Comments on Draft 1.2

**IEEE P803.2an Task Force
Vancouver, January '05**

Brett McClellan

Richardson's Method

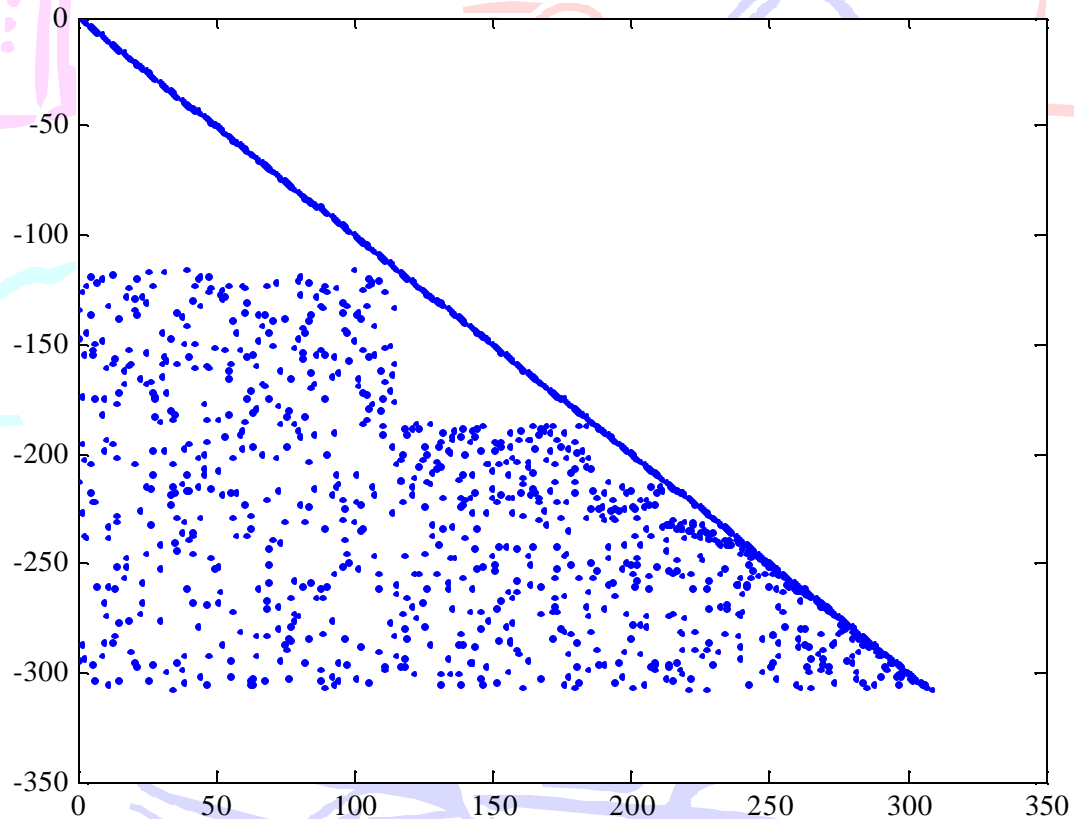
- T submatrix – lower triangular

(2048,1723) Example

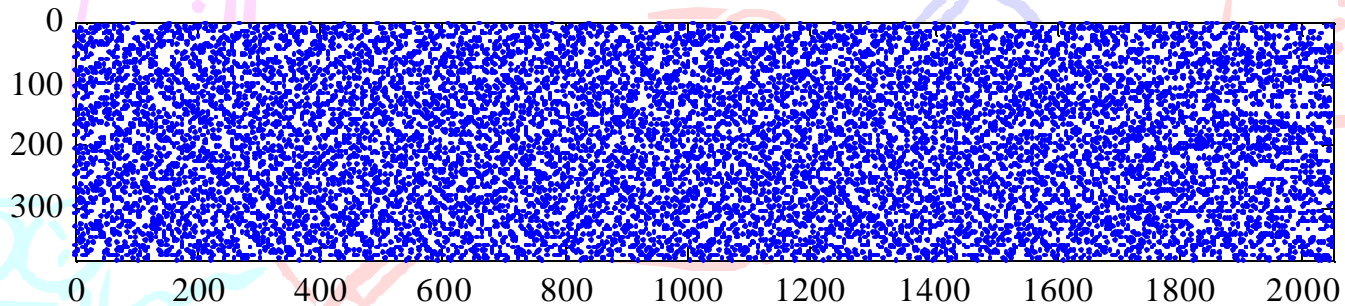
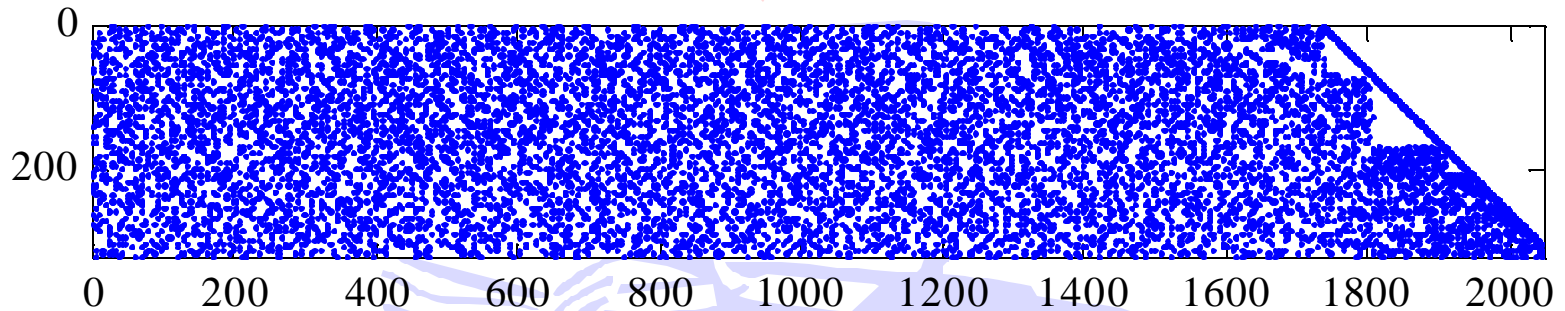
- H matrix w/ column swaps

- Approximate lower triangular

- Richardson's method reduces encoding complexity by more than an order of magnitude.
 - ~280k -> ~12k
- No effect on decoder performance
- Standard should specify H in sparse format
 - $384 \times 32 = 12888$ entries
- Standard should also specify the row swap vector to generate A,B,C,D,E & T
 - 384 entries
- The example matrix has been submitted to the editor

PCS Scrambler cont.

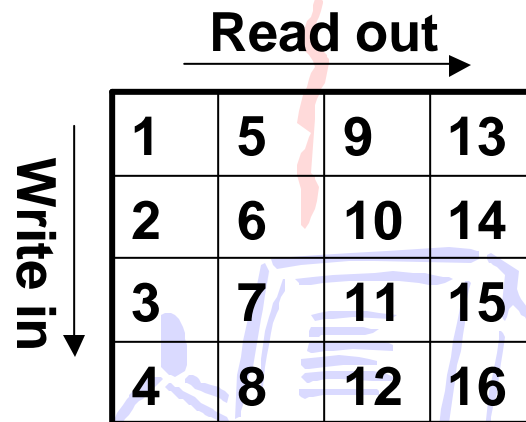
- For 10GBASE-T
 - Slave should transmit using $1+X^{19}+X^{58}$ polynomial
 - time reversed sequence
 - CRC added after scrambler / checked before descrambler
 - No error propagation in CRC check
 - Proposed “sync” bit can be traded for CRC8 vs CRC7
 - $(1+X+X^5 +X^6+X^8)$
 - Proposed “aux” bit can be traded for CRC9
 - $(1+X^2+X^3 +X^5+X^{10})$

Example

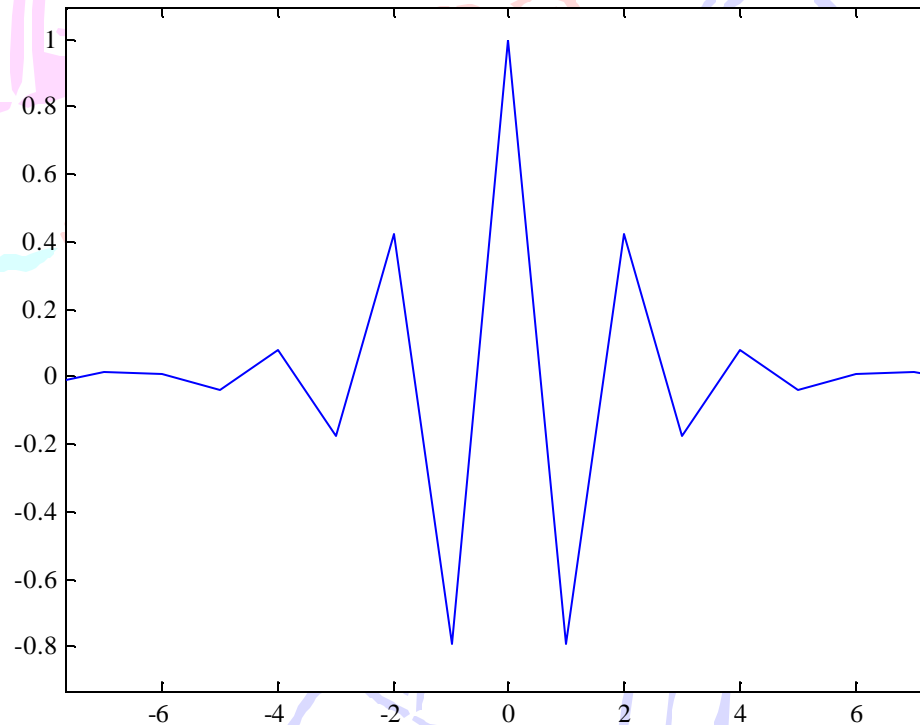
- Extreme noise correlation at EQ out:

- In extreme case, interleaver reduces noise by 3dB
